IEEE802.3at Task Force

Suggested Remedy for comment #183, 184

October 2007

Yair Darshan
Microsemi Corporation

Table TBD-1

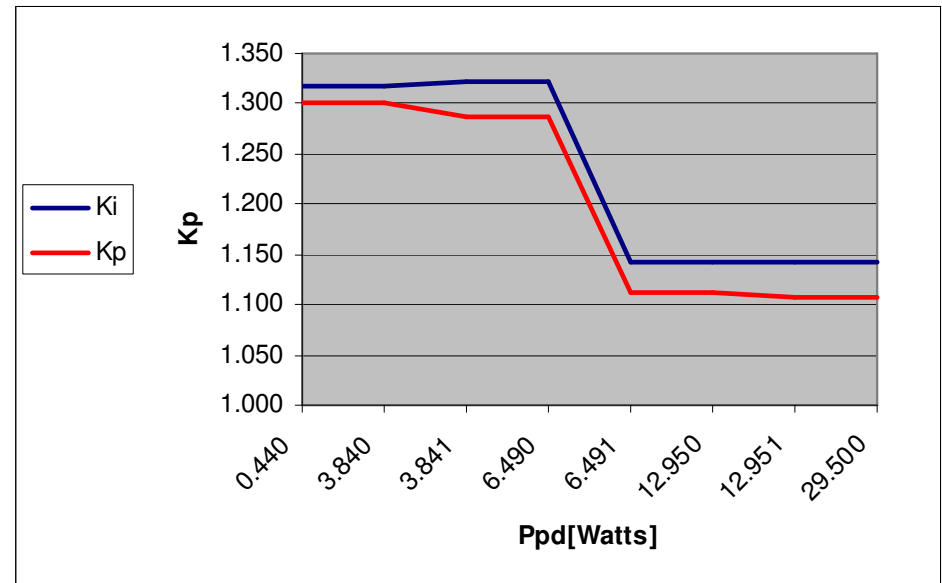
Eq-2 is just Informative..

It is better to allow higher I_{dc} for class 1,2 and to use the same 0.4/0.35 ratio for all classes

- $Ki_class = I_{peak} / I_{avg}$. → Ki_class determines I_{peak} , P_{peak} .
- Kp_class is a function of Ki_class , V_{pse} and I_{port_avg} . It is not a constant actually it is a complex variable.
 - Kp transforms current to power in the PD constant power equations.
- Using only Ki as proposed in the Table below allows meeting all our objectives

1. Table 33-12 item 4: Change symbol from “Iport” to “Iport_peak”
2. Replace the equation “ P_{port_max}/V_{port} ” with “Iport_peak as defined by Table 33-12 item 4”.
2. Add the text “Iport_peak is approximated by Eq-3”
3. Add equation Eq-3, Eq-1 and Ki_class constants from Table TBD1 to table 33-10 in separate column.
4. Update accordingly 33.2.8.4 and 33.2.8.4a by removing “ $17.6W/V_{port}$ ” and referring to Eq-1 and Eq-3.
5. Update 33.2.8.6 to reflect the above changes.
6. **See attached word document for detailed remedy**
